Revisions	Amendment 1	10/20/2014
1

Drawing Title
PHASE 1 - BASEMENT FLOOR PLAN
Approved: Project Director

Project Title
INSTALL NEW HVAC IN AUDITORIUM
Location
Cincinnati, Ohio
Date
05/23/2014
Checked
DLE
Drawn
WJS
Project No.
VA Project No. 539-15-202
Building Number
1
Drawing Number
MH101
Dwg. of
xx
Office of Construction and Facilities Management
Department of Veterans Affairs

PHASE 1 - BASEMENT FLOOR PLAN - DUCTWORK

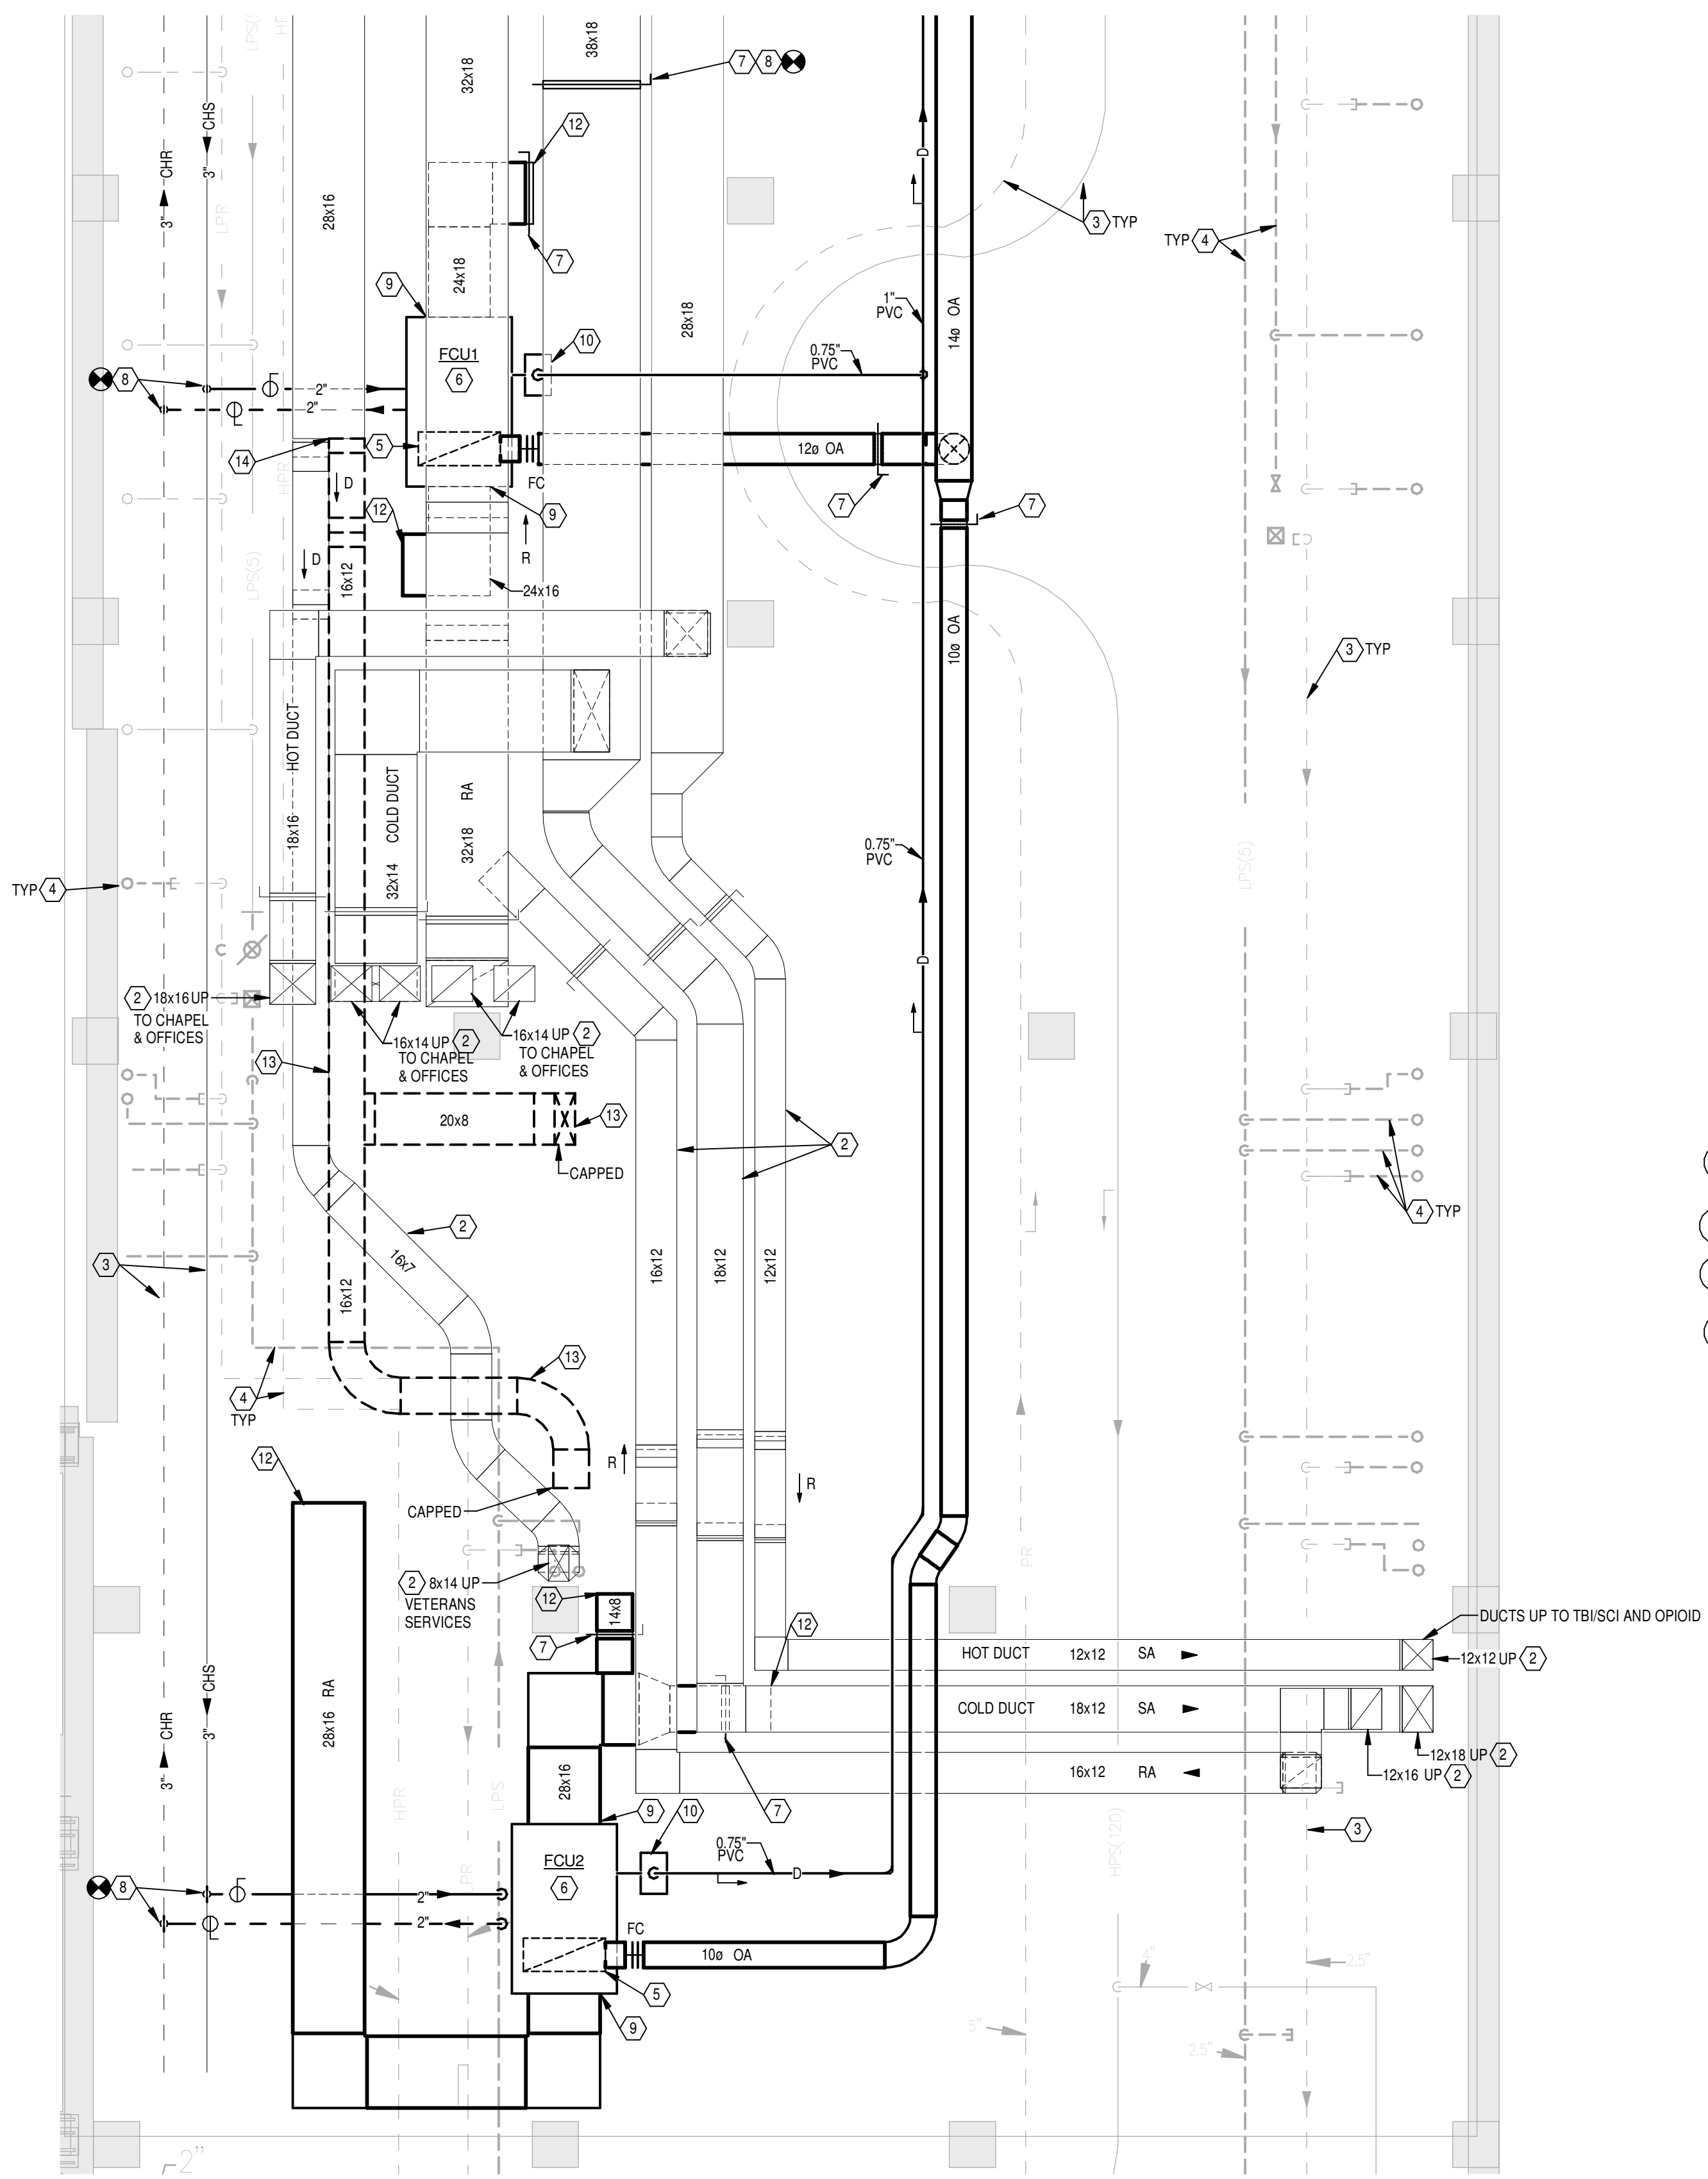
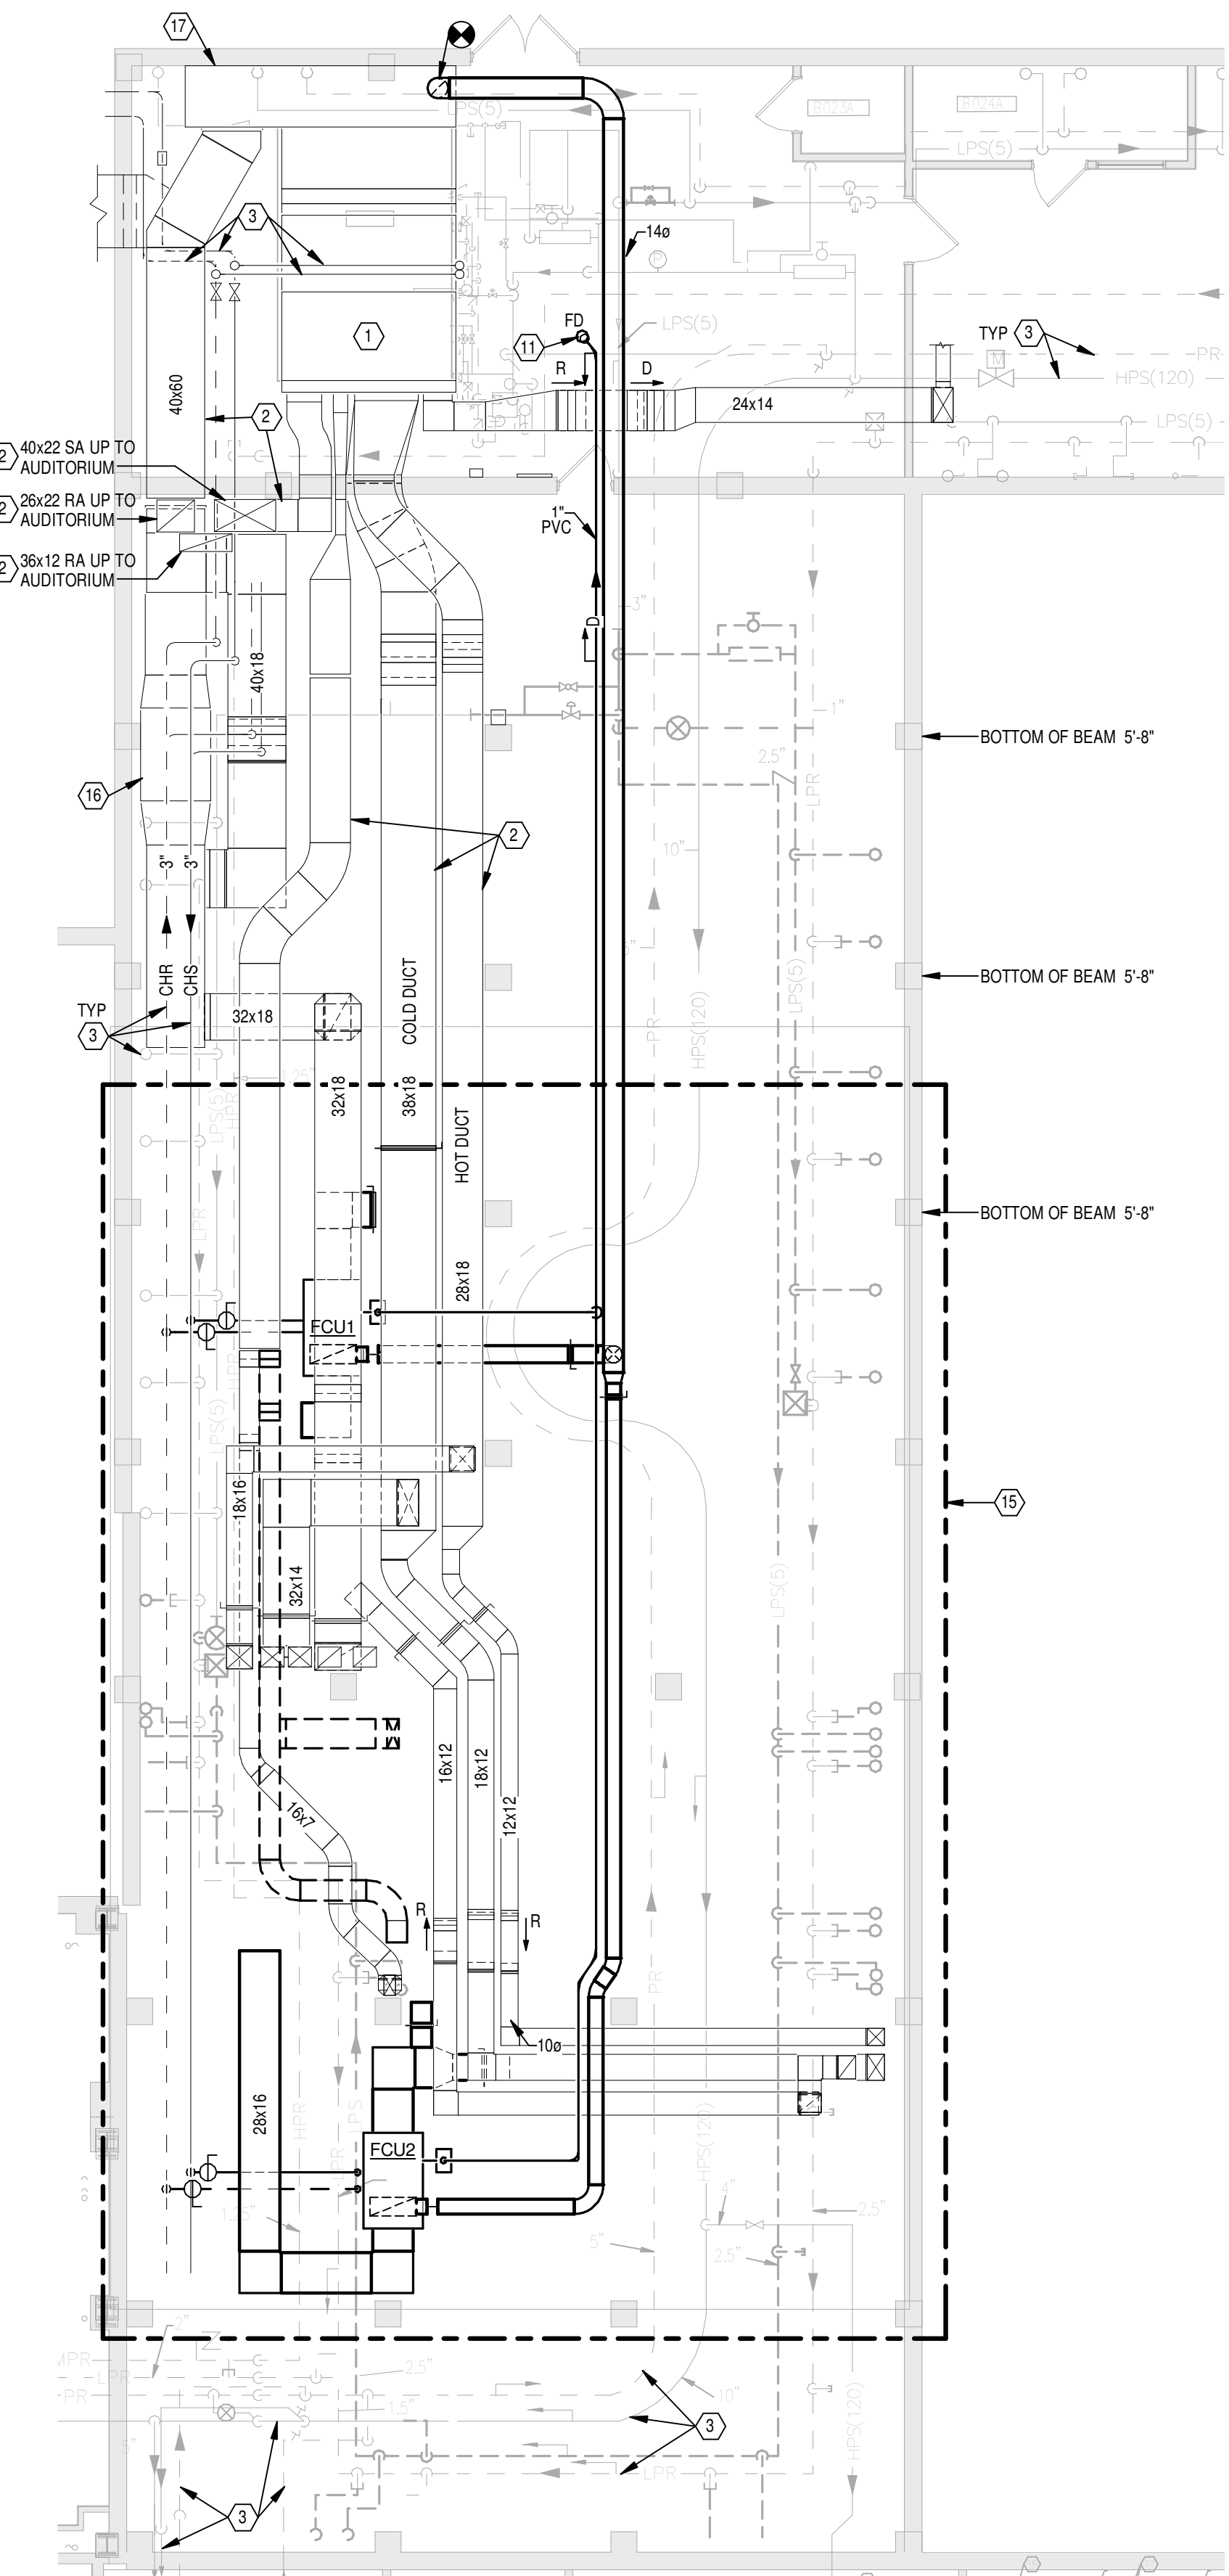
DELETE ALL WORK ON THE SHEET AND PROVIDE SIX 1.5 TON TEMPORARY 120V CORD AND PLUG TEMPORARY INDOOR COOLING UNITS WHILE 1-AHU21 IS OUT OF SERVICE. LOCATE UNITS AND EXTEND HEAT DISCHARGE DUCTS AS DIRECTED BY PROJECT ENGINEER.
